SAFETY EVALUATION BY THE OFFICE OF NUCLEAR REACTOR REGULATION

ON MAIN STEAM LINE BREAK - SINGLE FAILURES

CONSUMERS POWER COMPANY

PALISADES PLANT

Figure 1 Palisades main system and feedwater system

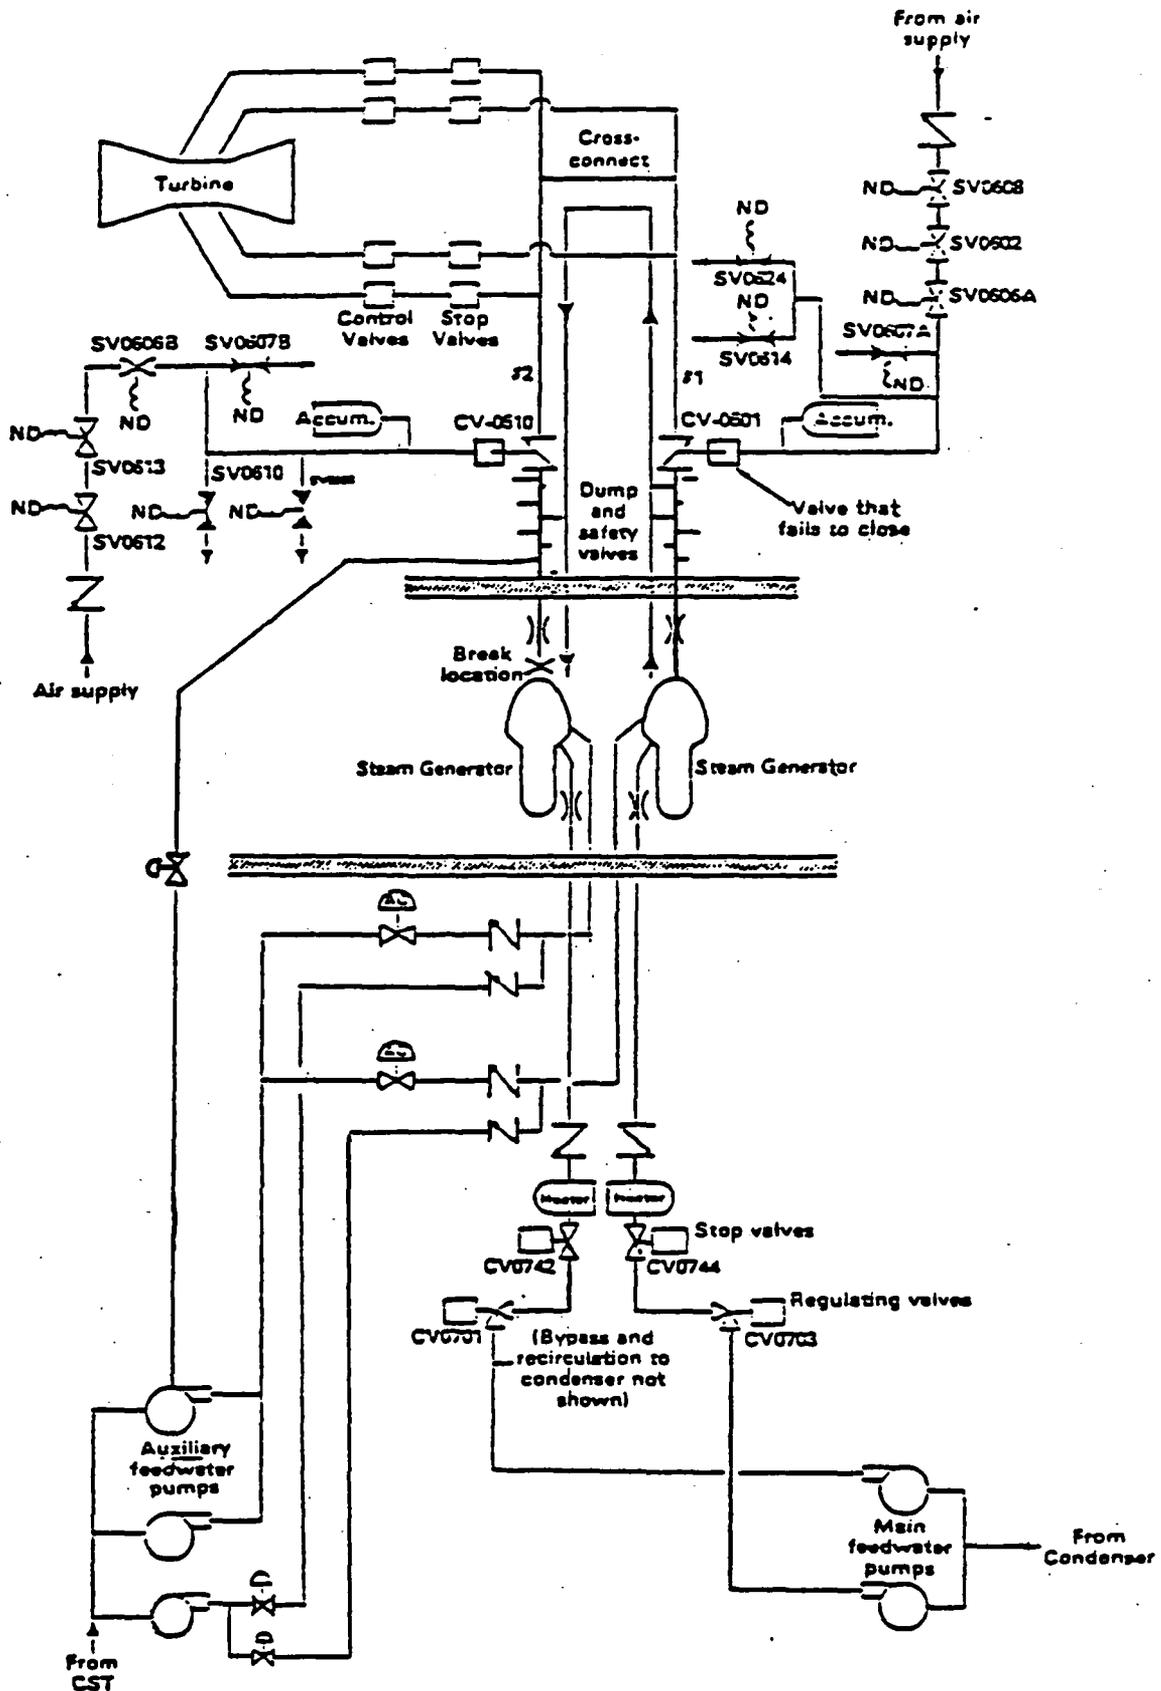
The staff noted that for breaks on the reactor side of the MSIV, a single failure of the MSIV in the other loop would allow both steam generators to blow down (See Figure 1). Because of the cross-connect line, only the MSIV can provide isolation between the steam generators for such an event. The MSIV, being a check valve, can only withstand a differential pressure in one direction, namely a higher pressure on the steam generator side of the valve. If the valve in the intact loop fails to close, the steam flow from that generator can flow through the cross-connect line, through the MSIV in the broken loop and out the break.

The staff was concerned that a double generator blowdown could interfere with successful decay heat removal. The loss of steam pressure would cause the turbine-driven AFW pump to be disabled, leaving only one motor-driven AFW pump (the second motor-driven pump had not been installed at the time of the SEP topic evaluation). Also, the staff postulated that the operator may have difficulty controlling this event which is outside the bounds of the original safety analysis. Furthermore, analysis of the containment response resulted in calculated peak pressure of 107 psia, which exceeded the containment design pressure. Because of these uncertainties, the staff identified this issue as important to risk in the integrated plant safety assessment report (IPSAR) for Palisades, NUREG-0820. By letter dated February 16, 1982, the licensee committed to make modifications to make the main steam system single failure proof with respect to this concern.

The staff has reviewed the expected response of the Palisades Plant to main steam line breaks (including valve openings) with the existing plant design. The potential improvement to safety derived from previously identified plant modifications (MSIV replacement or addition, redundant feedwater isolation) was also assessed. As discussed above, a double steam generator blowdown or a single generator blowdown with continued feedwater addition, although more severe than the licensing basis MSLB accident, is not expected to result in unacceptable consequences. Furthermore, the risk evaluation demonstrates that the potential offsite consequences are low and that the modifications would not provide a substantial improvement in plant safety.

As previously discussed, the staff's major concern for MSLB and MSIV failure was for decay heat removal capability. The staff notes that plant changes have already been implemented to improve AFW system reliability, such as installation of an additional motor-driven pump. The effects of addition of cold AFW to a dry steam generator have been found acceptable. Because the MSIV modification only affects AFW system reliability and equipment qualification (see below) for a limited set of initiating events, the cost-benefit evaluation indicates that the justifiable costs (averted risk) is small. Nevertheless, there are procedural improvements for operator response to steam line breaks, single or double generator blowdown, that will enhance the likelihood of successful decay heat removal, even with faulted steam lines.

FIGURE 1 PALISADES SUMP

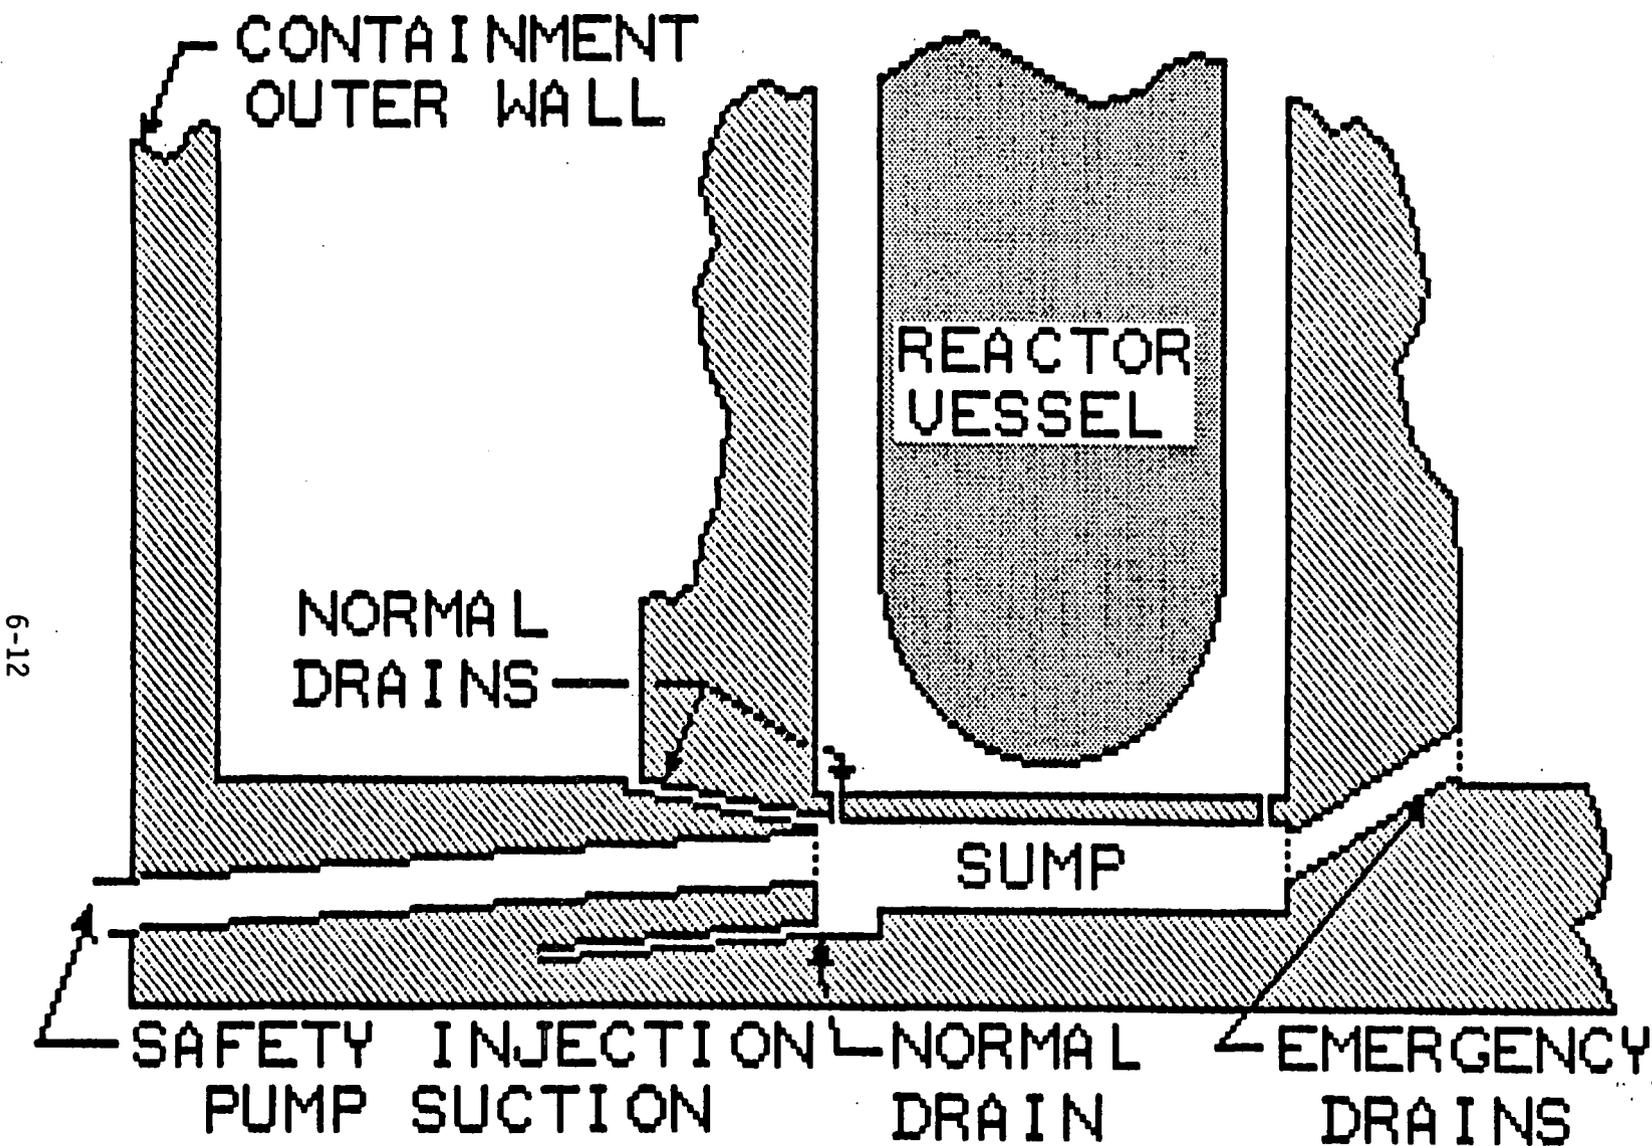
If a high pressure blowdown of melt were to occur through the reactor vessel bottom, the first two items in the above list would probably provide the largest vent paths. The others are probably too small to affect short-term containment response. Melt ejected from the reactor cavity via the access passage would encounter a tortuous path prior to reaching upper containment. The staff opinion is that most melt entering this path would be removed before reaching the large open volume of upper containment. Melt ejected up the annular space would be restricted at the seal region, and would impact upon the missile shield prior to reaching upper containment. The staff judgement is that most of the melt entering this path would not pass into upper containment as an aerosol, which would be necessary for a significant chemical reaction to occur.

The dynamic interaction between high pressure melt ejected through the bottom of the reactor vessel and the concrete floor immediately below has not been analyzed, but the staff judges that the floor would not survive. Even if short-term survival did result, drains between the bottom of the reactor vessel cavity and the sump would provide a path for passage of melt and the flowing melt material would probably increase the diameter of the drains. This path also would be applicable to melt-through of the lower vessel head with the RCS at low pressure. Therefore, the conditional probability of a significant quantity of debris being deposited in the sump at the time of reactor vessel breach is considered to be one.

Debris in the sump may block the pipes leading to the safety systems, or debris may be sucked into the pumps. The staff will assume the conditional probability of one that significant blockage of these pipes will occur, given the presence of a significant quantity of melt material or debris in the sump. It further appears reasonable to assume that any pumps using the sump as a source of water will be destroyed or badly damaged if they are in operation at the time of reactor vessel breach. The conditional probability of this reaction will also be assumed to be one.

Seal damage which releases a significant quantity of radioactive material outside of containment may be a result of pump operation during the above discussed conditions. Movement of melt into the pipes, which are 24 inches in diameter and have a slight slope toward the outside of containment, could lead to penetration of the containment boundary with release into the auxiliary building. Other failure mechanisms can be postulated which would fail the pipes, including short-term overpressure in response to molten material interacting with water in the vicinity, and blockage of the entrance region of the pipes followed by pressurization from heating of trapped water. None of these has been investigated. For purposes of this evaluation, the staff will assume a small conditional probability for failure of suction lines leading to bypass of the containment boundary given the release of molten core material into the sump.
